Aurum Sweater Ltd.

6th July 2017

Observations

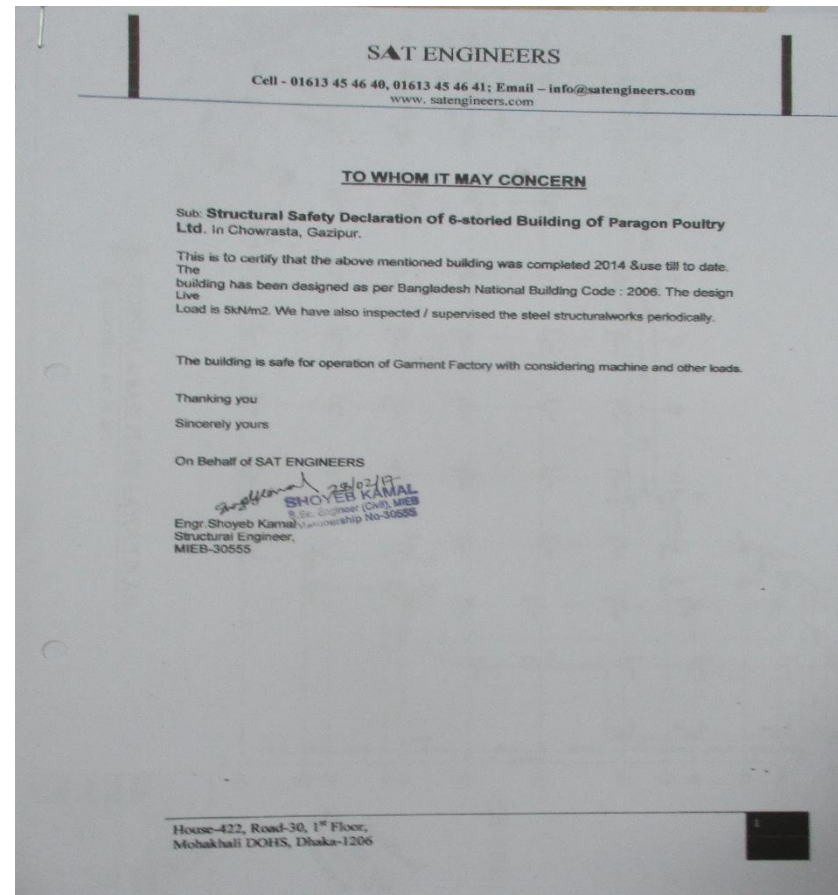
Steel columns to be stressed above normal design limits as per load certificate

Factory has provided a load certificate that the building has been designed as per BNBC 2006 and the design load is 5kpa. Design review is required if the factory management wants to implement the load plan according to BNBC.

Factory is required to maintain the floor live load 3kpa until further verification by design engineer.

During inspection no over loading was observed and FOS calculation for internal column was found satisfactory considering 3kpa allowable floor live loading.

Discrepancies between drawings and on site condition

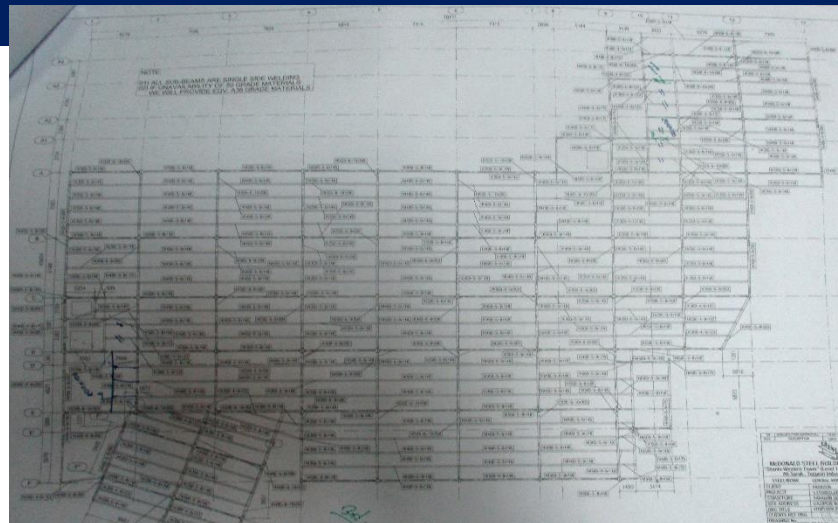
All Column & beam dimensions didn't match with provided drawings. Building engineer is required to produce an "as constructed" drawings which reflect the actual site dimensions with complete structural information.

Extra Steel Column

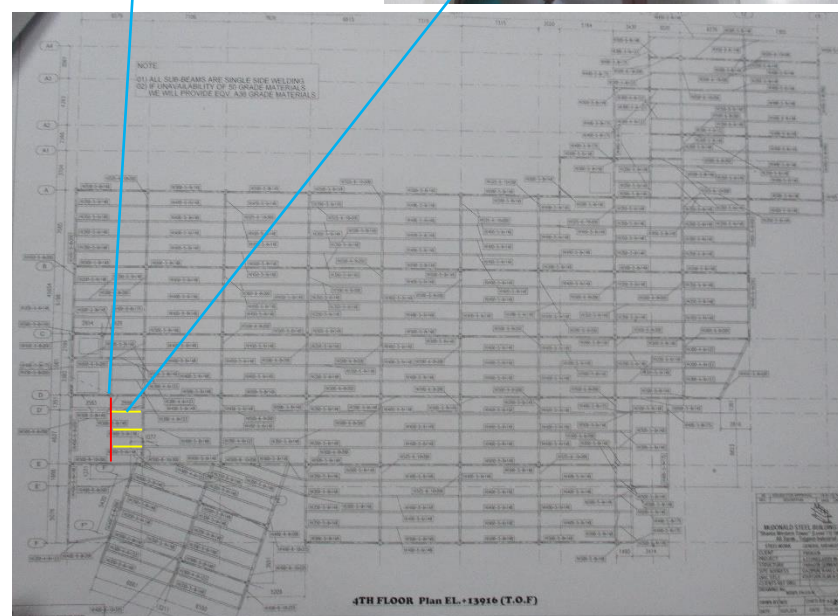
Extra steel column was found which is starting from beam at 2nd floor near front stair. Few beams were not shown in beam-layout which actually exist.

Bolt missing and Improper connection

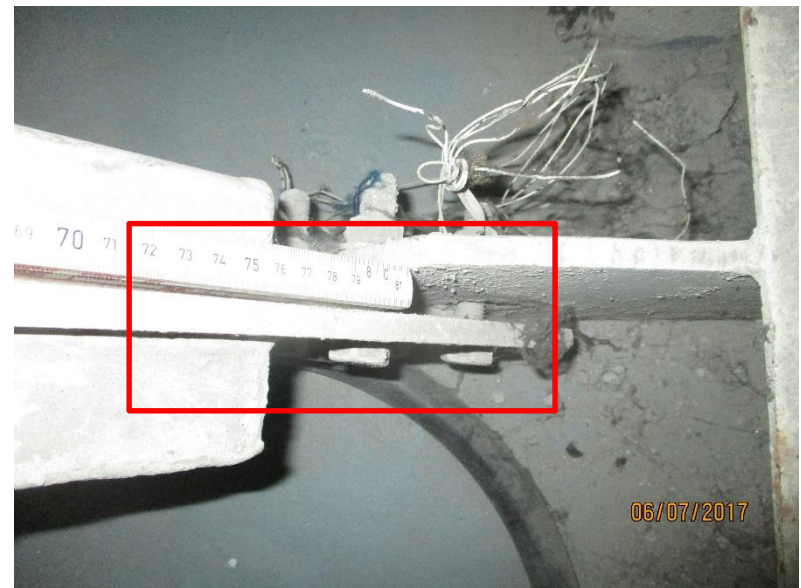
Missing and loose bolt found in several location.

Improper connection found in beam-column joint and bracing joint.

Item No.	Observation	Recommended Action Plan	Recommended Timeline
6	(Main Factory Building) Bolt missing and light connection	Factory Engineer to check the member joints and install missing Bolts.	6-weeks
7	(Main Factory Building) Bolt missing and light connection	Factory Engineer to snag all light connections and take remedial actions if required.	6-weeks
8	(Main Factory Building) Corrosion found in beam column joint and column base plate at toilet zone	Apply suitable method to protect the steel members from corrosion.	6-weeks
9	(Main Factory Building) Corrosion found in beam column joint and column base plate at toilet zone	Complete further testing on areas of deterioration and have a structural engineer develop a remediation plan.	6-months
10	(Main Factory Building) Apparently non engineered stair with poor support condition	Factory Engineer to install adequate structural members to stable steel stair.	6-weeks

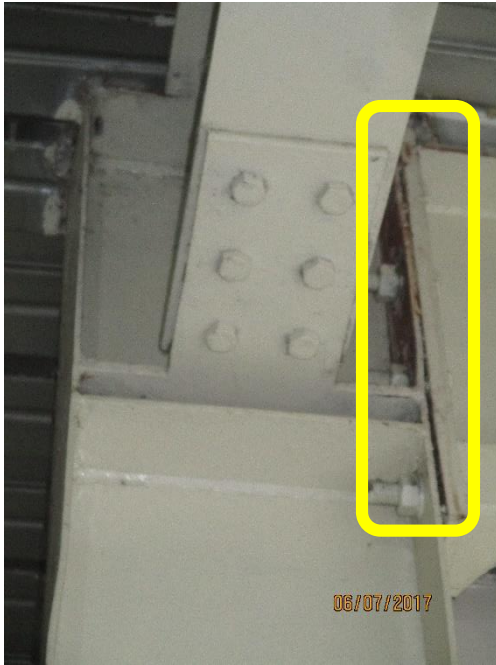
Corrosion found in beam column connection and column base plate joint at toilet zone

Corrosion at beam-column joint

Corrosion at column base inside toilet zone

Apparently non engineered stair with poor support condition

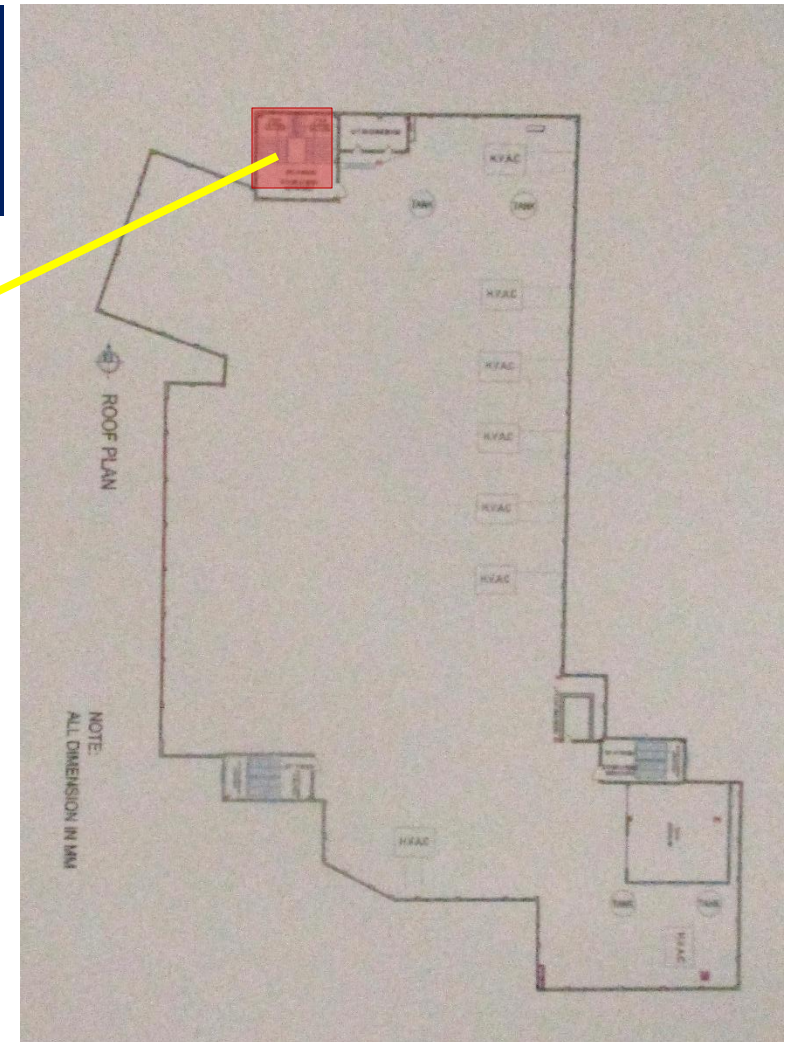
Apparently non-engineered steel stair on roof. Steel pipes are poorly welded with roof slab. The stair does not have adequate bracing and the connection to the building and it appears to be poor.

Columns susceptible to vehicle impact

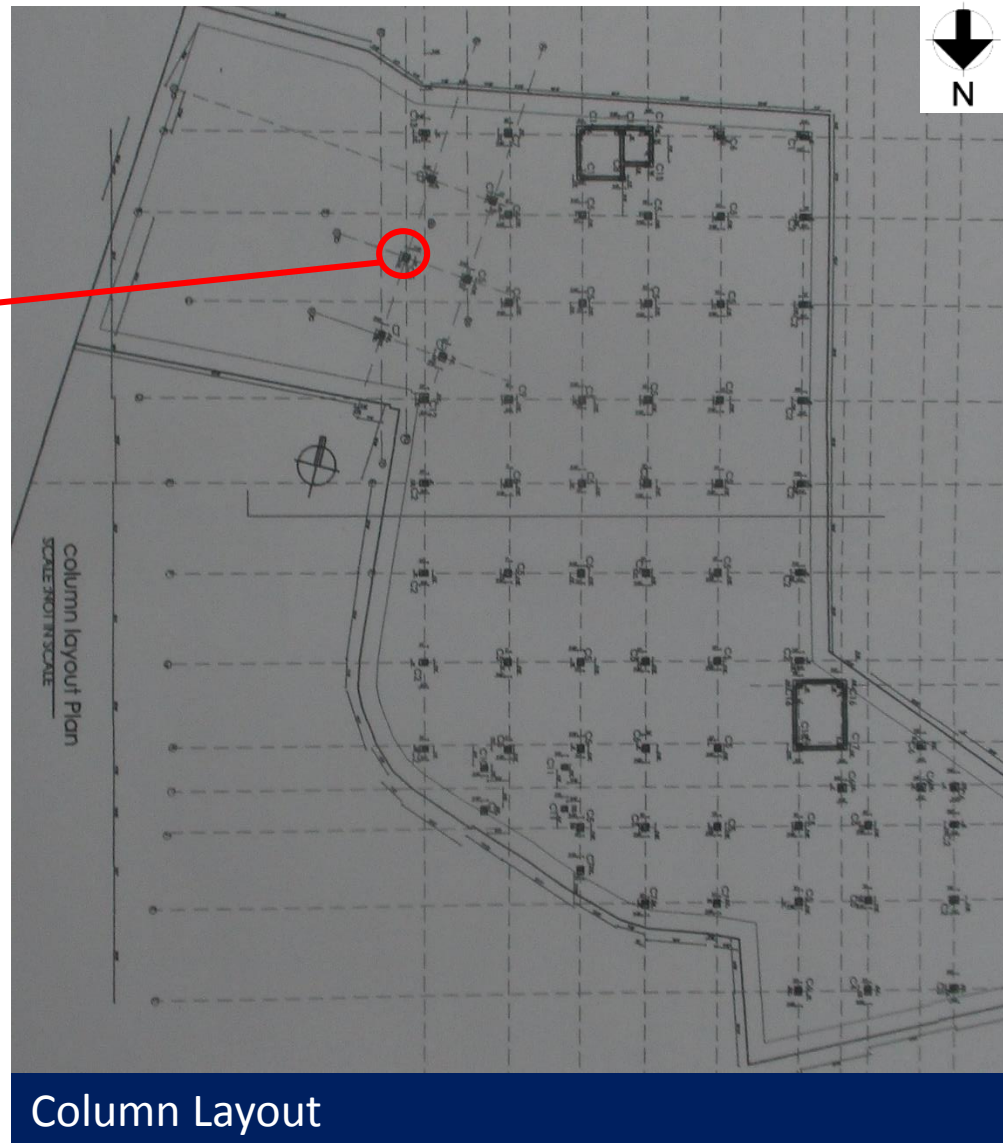
Impact protection not provided to columns at loading –unloading area. Columns are susceptible to impact loading from vehicles.

Item No.	Observation	Recommended Action Plan	Recommended Timeline
11	(Main Factory Building) Falling hazard risk at roof	Provide proper edge protection at mentioned area on roof.	6-weeks
12	(Main Factory Building) Columns susceptible to vehicle impact	Install a barrier to prevent vehicle impact in column.	6-weeks
13	(Utility Buildings) In sufficient documents for Utility buildings.	Prepare up-to-date as-built documentation for all utility buildings.	6-weeks
14	(Utility Buildings) Apparently non-engineered connection (Generator room & Pump house)	Building engineer to check the capacity of the lightweight steel roofs under lateral and vertical loading.	6-weeks
15	(Utility Buildings) Apparently non-engineered connection (Generator room & Pump house)	Carry out remedial works resulting from engineering assessment of building.	6-months
